From: "Kathryn Drew" <kdrew@bbo.co.nz>
Sent: Thu, 6 Oct 2022 15:03:37 +1300
To: "Tim Wilson" <tim@kineticenvironmental.co.nz>
Cc: "Ciaran Murphy" <ciaran@kotareconsultants.nz>; "Kevin Hill" <kevin.kph@xtra.co.nz>; "Emma Ruttley" <Emma.Ruttley@waipadc.govt.nz>
Subject: External Sender: RE: Te Awa Rise Ltd - Waipa DC further information request
Attachments: Response to s92 Request - District Council.PDF

On behalf of Te Awa Rise Ltd please find attached a response to points 1-16 of the Waipa District Council s92 request for SP/0107/22 & LU/0161/22.

Response to Request for Further Information under Section 92 RMA

Figure 1: Conceptual Swale Design

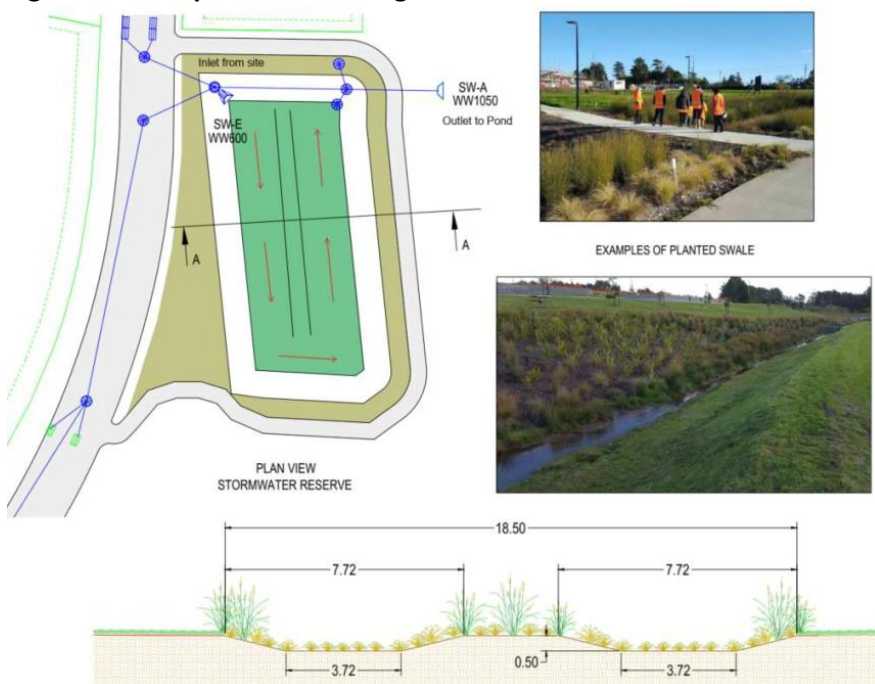
6. Lot 400 (proposed local purpose (stormwater) reserve)

The majority of Lot 400 is not proposed to be mown, instead will be planted as per the details in the Te Miro Stormwater Report (Appendix M of the AEE) and the concept plan below. Future detailed design/planting plan will be provided to Council as part of engineering design approval and conditions of consent to this effect are expected. The only portion of Lot 400 that may require mowing is the edges of the walkway. Anything over 1:3 will be planted.

SUBDIVISION CONSENT PLAN
 LOTS 1-54, 100-102, 201-205, 301-305, 400-401, 501-503, 600 & 601 BEING A
 SUBDIVISION OF LOTS 1&2 DPS 90107, LOTS 1&2 DP 506796, & LOT 3 DP 331365
 AT 3784, 3794, 3796, 3798, & 3838 CAMBRIDGE ROAD, CAMBRIDGE 3495
 TE AWA RISE LTD

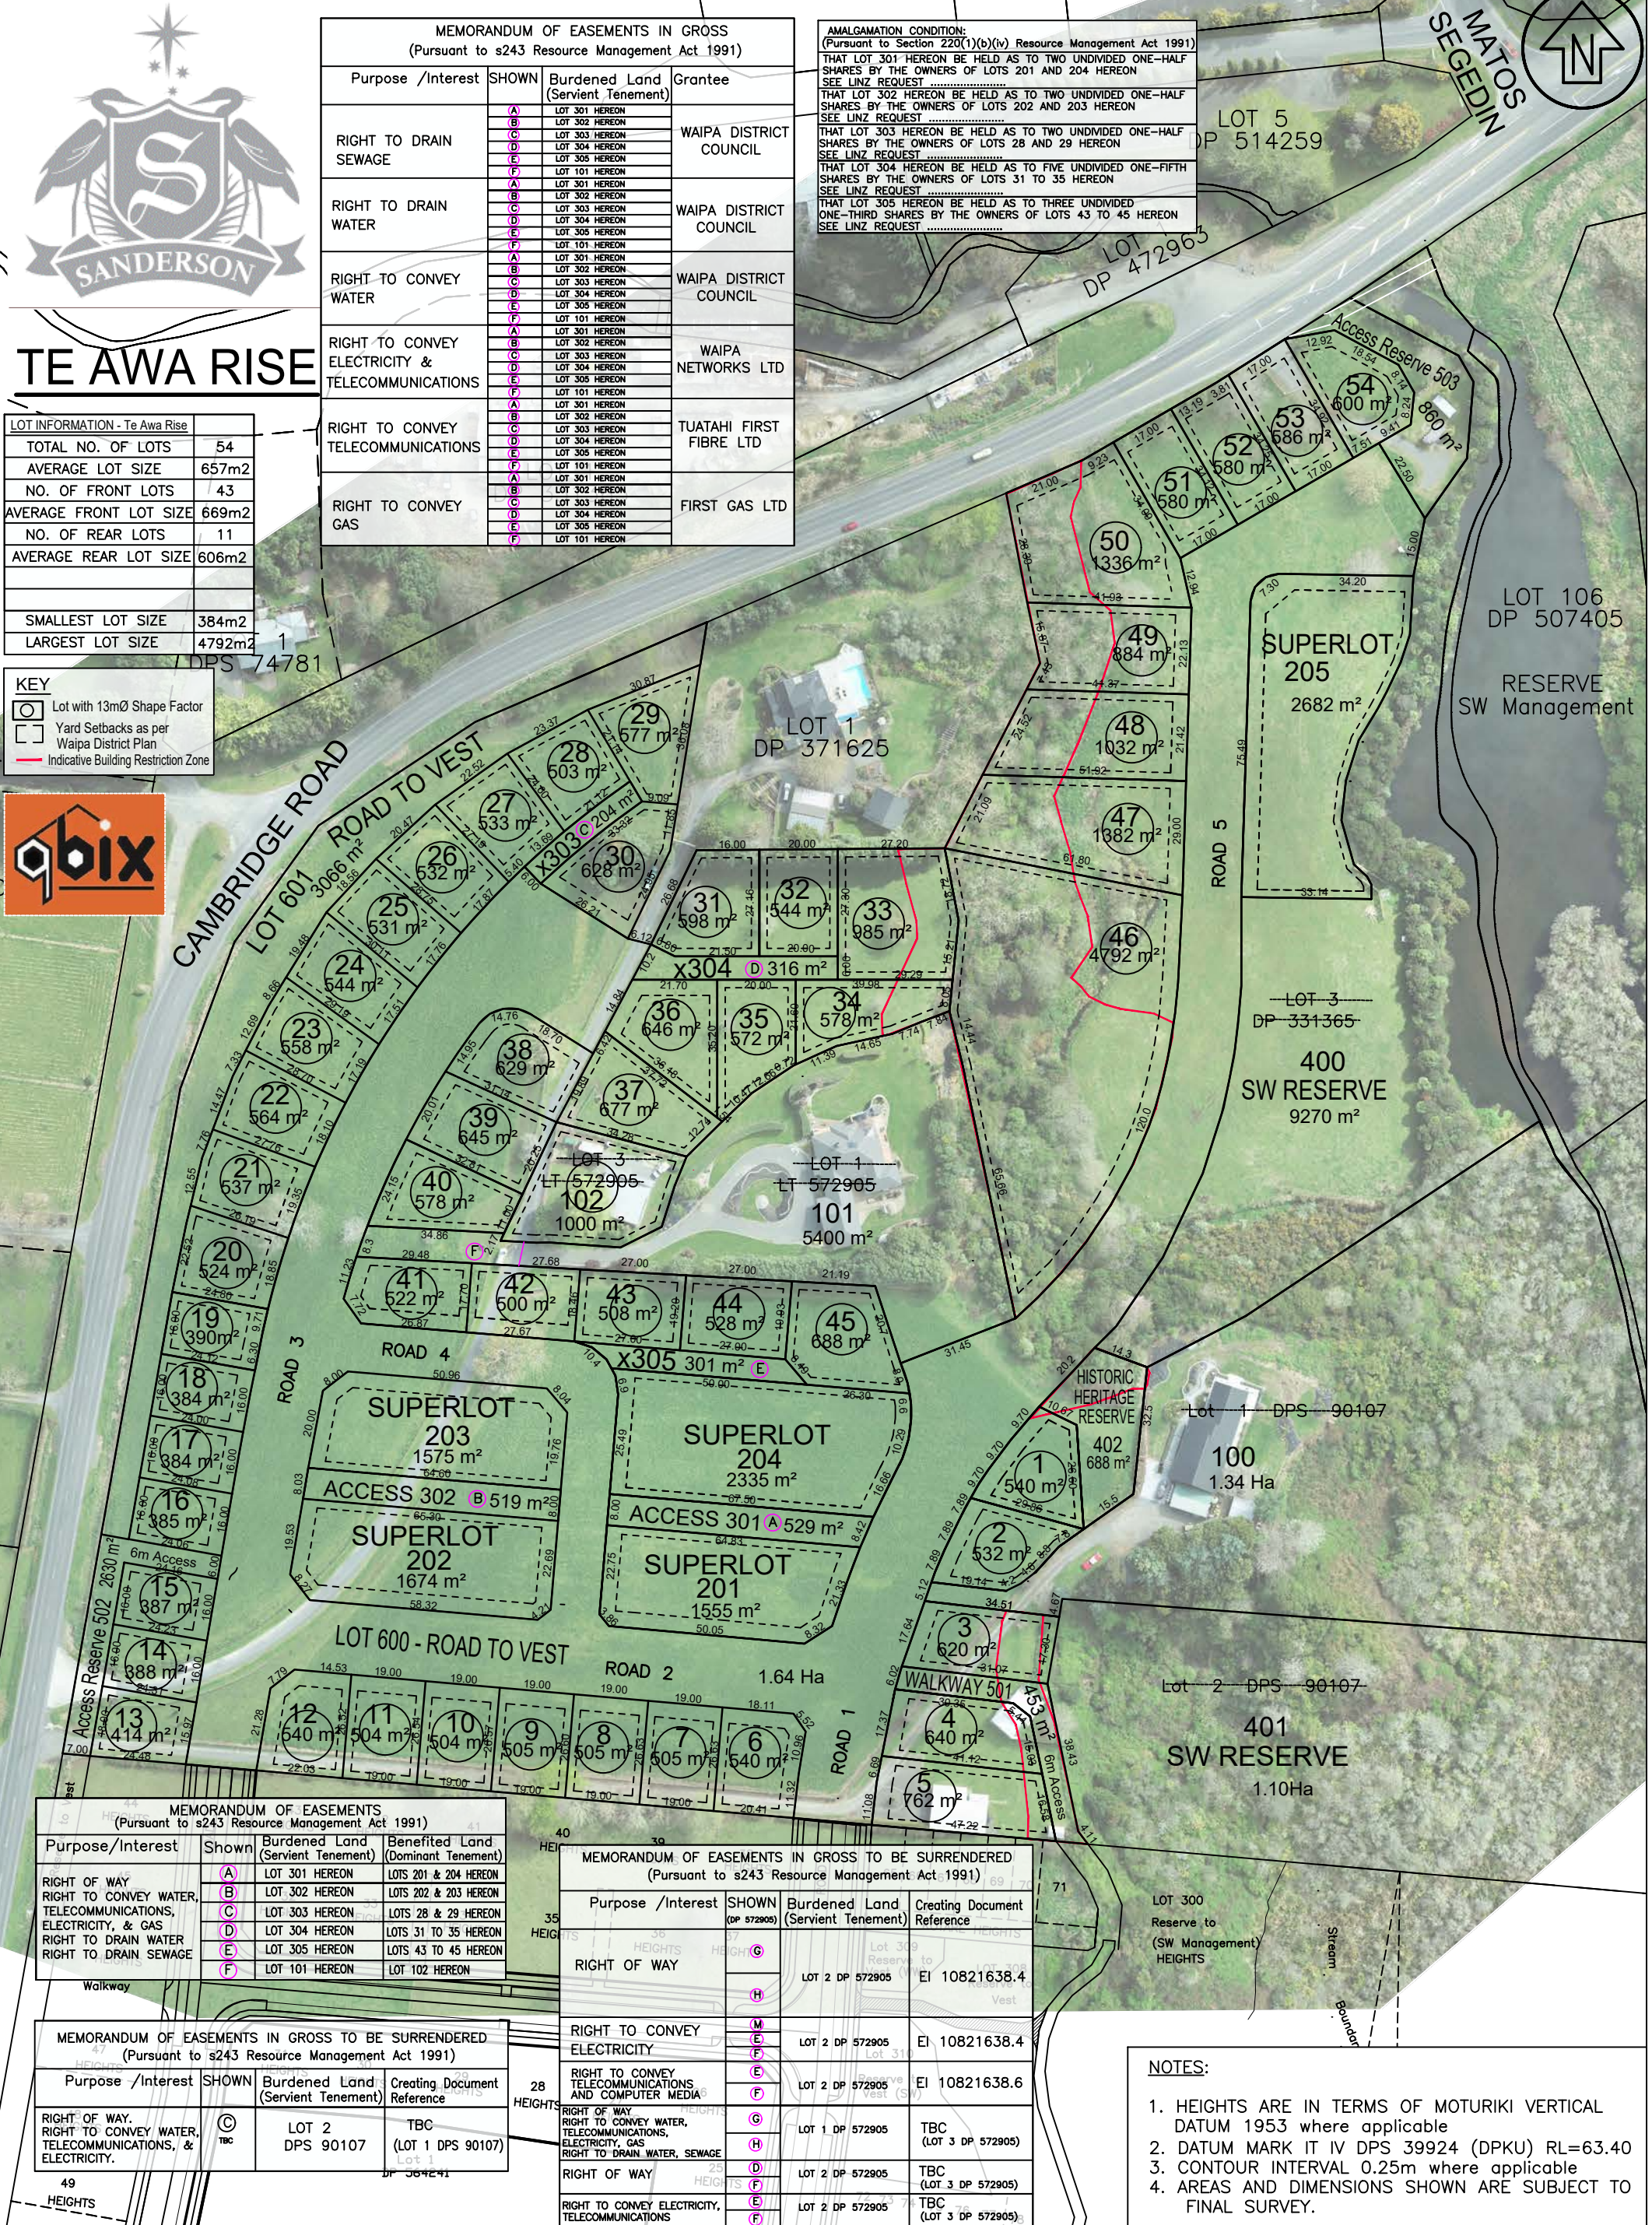
Prior to delving into the RFI detail, please note that the following changes have been made to the scheme plan, as a result of engagement with Council staff (Tony Coutts) around the Cambridge Road widening works and in response to the RFI:

- Lot 601 has increased in size and encompasses all of the land along the western edge of Lots 16-29. This change has been made to facilitate the road widening and provision of the pedestrian path within the new road carriageway along with retaining that Council is working on.

- The only change in lot size, along the western boundary is to Lot 19 which has increased in size from 388m² to 390m².
- Lot 503 has reduced in size to now only encompass the land at the northern end of Lot 54. This means that the land area of Lots 50-54 has increased in size.

A Building Restriction Zone as per the CMW Geosciences Report has been added to the Subdivision Consent Plan in **Attachment 1**. It is noted that suitable building platforms sit outside of those setbacks.

FINISHED SUBGRADE LEVEL PLAN

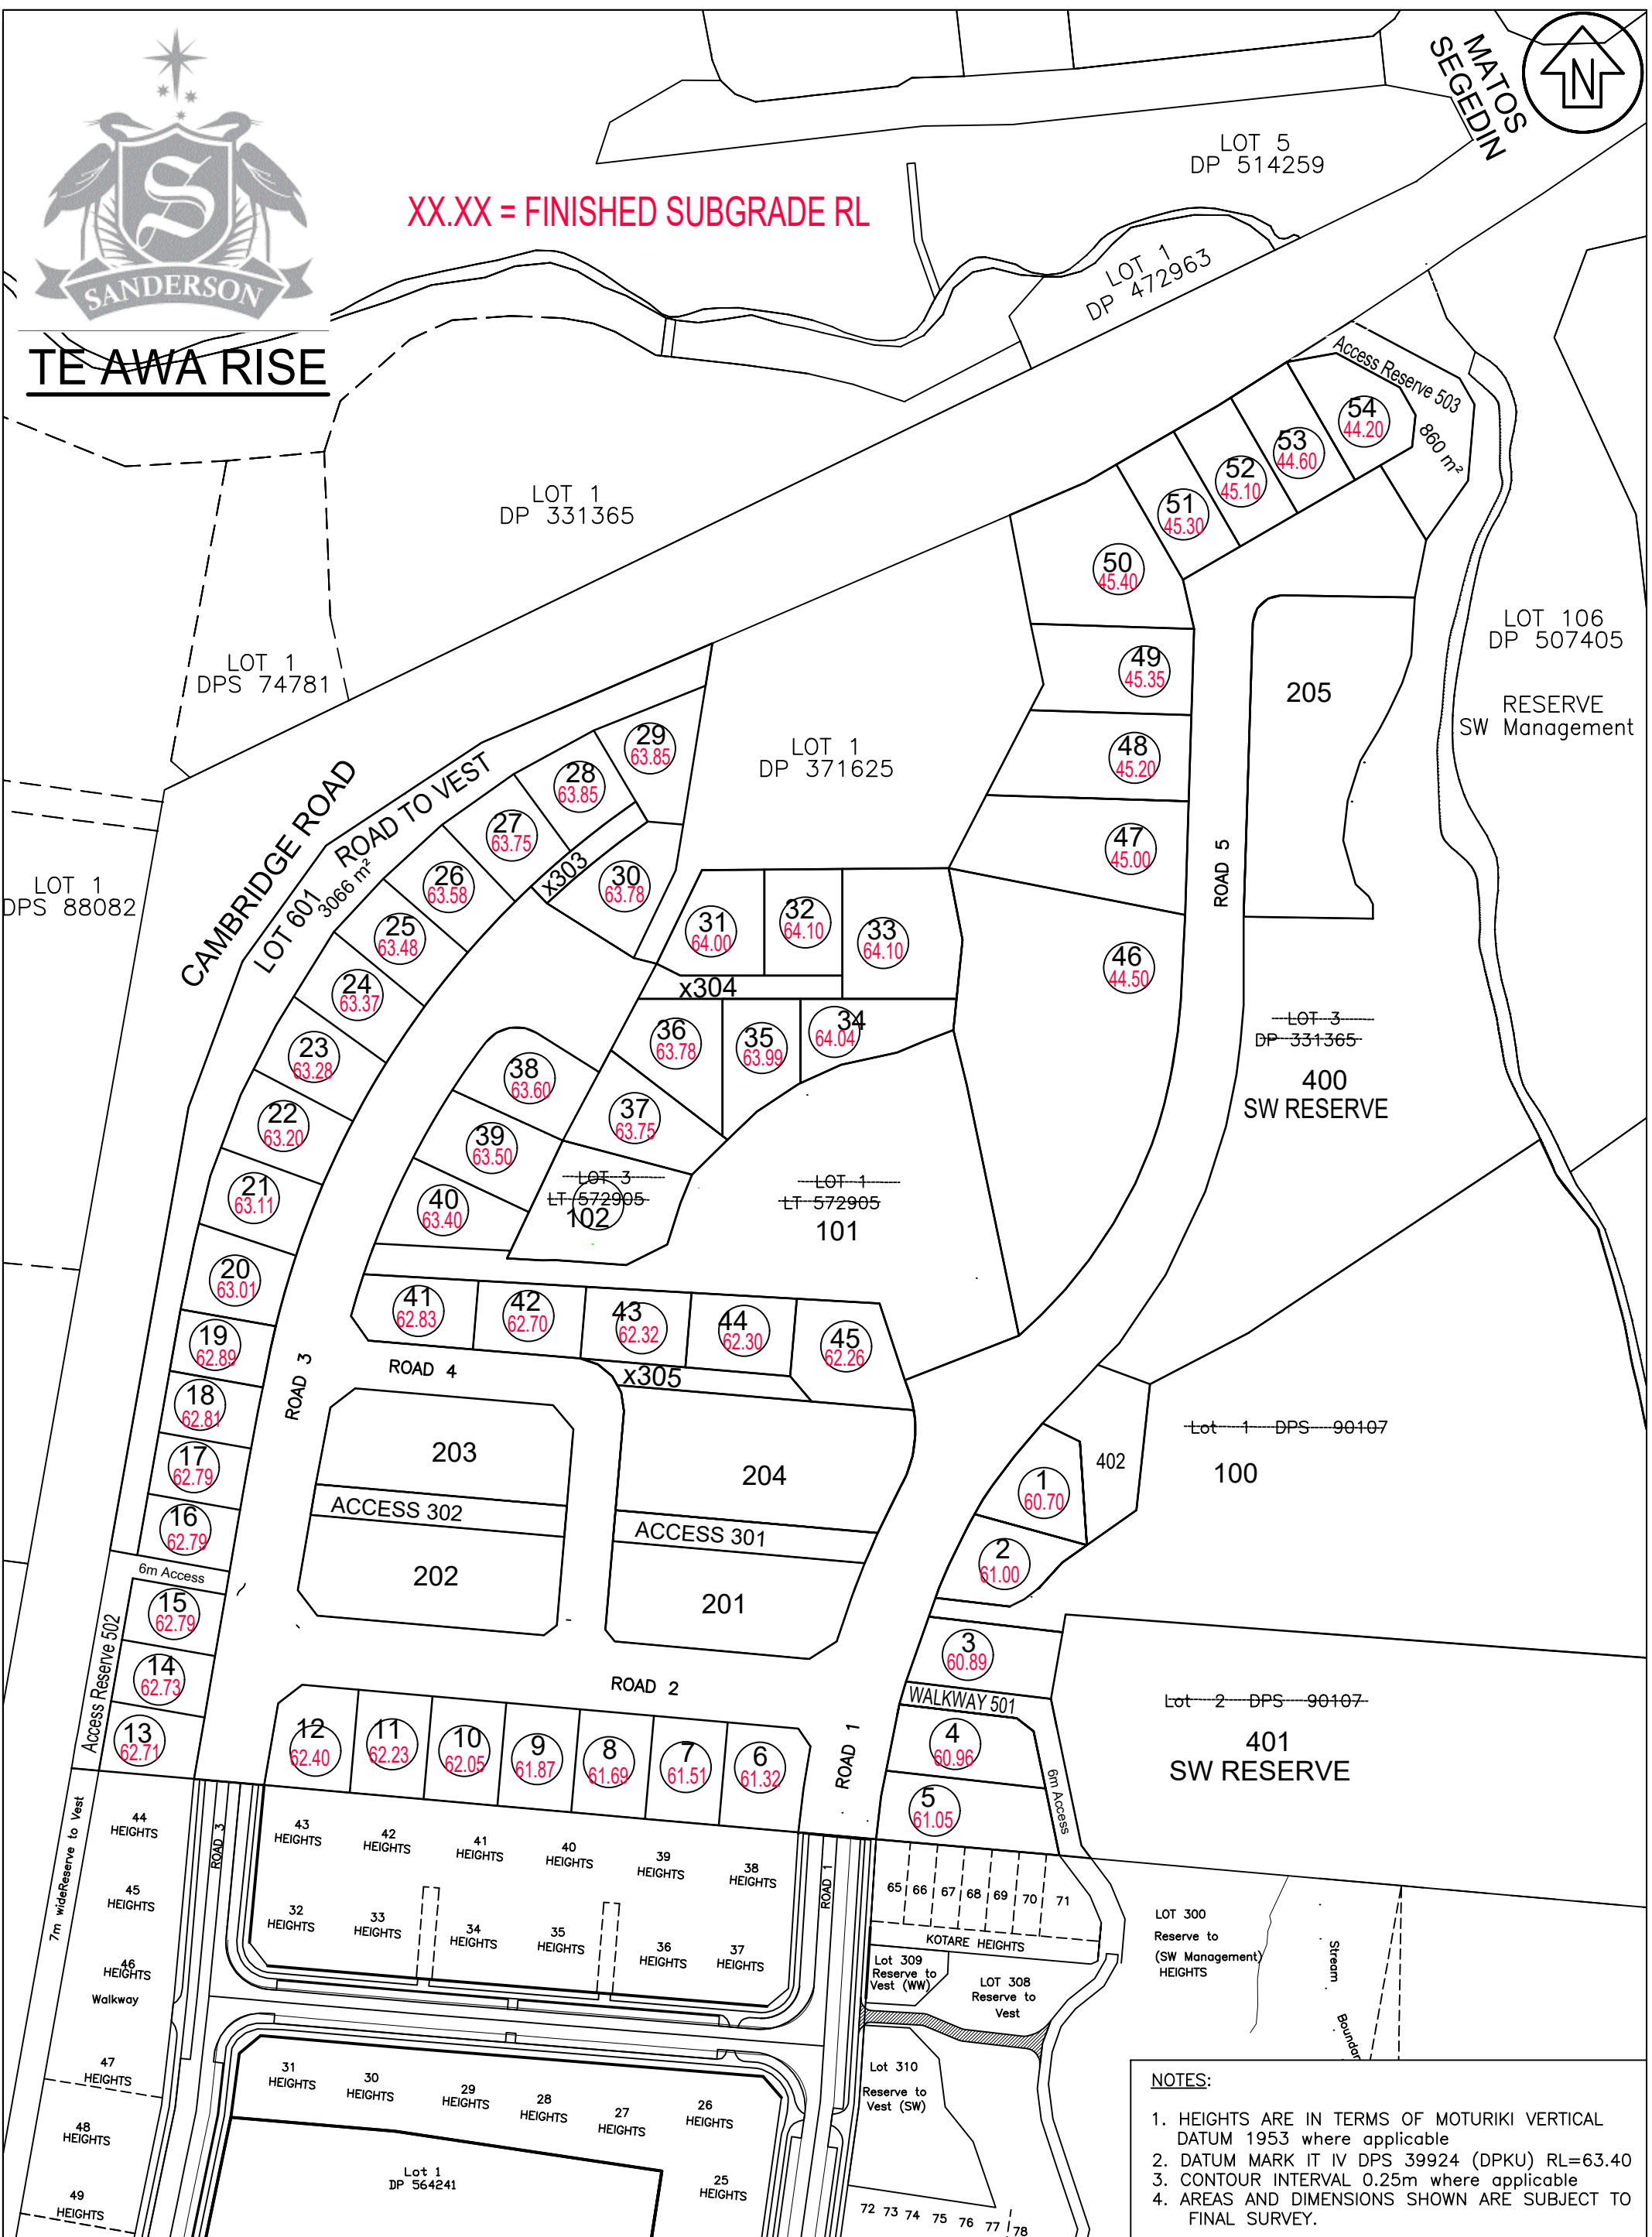
There is no planned re-use of contaminated soils exceeding the adopted human health guideline criteria on Lot 400. As per the earthworks plans filling of approximately 1m is proposed across this lower terrace, or where the swale is located the profile will be at existing ground level, not below existing ground level.

Refer to Plan 1034 – Sheet 06 for the cut/fill levels.

TYPICAL CROSS-SECTION 3m WIDE SHARED PATH WITHIN 6m CORRIDOR – GULLY LOT 501

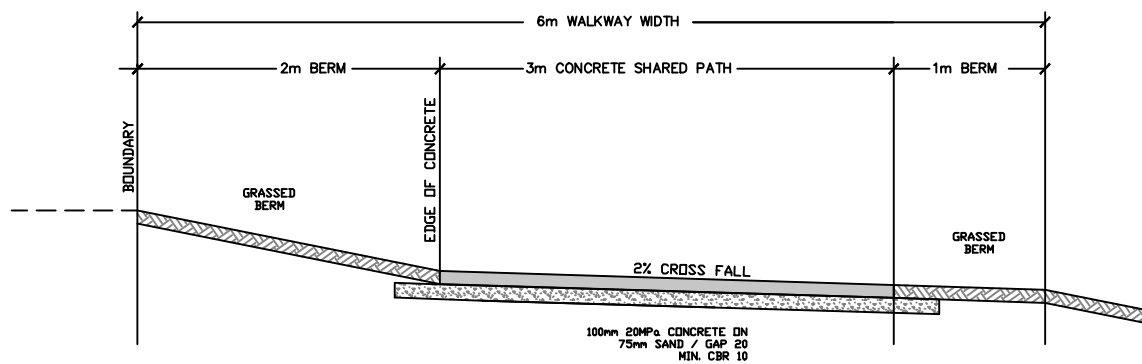
7. Walkway 501 and Lot 401

Refer to Plan 1034 – Sheet 10B for the cross-sectional profile of the walkway.
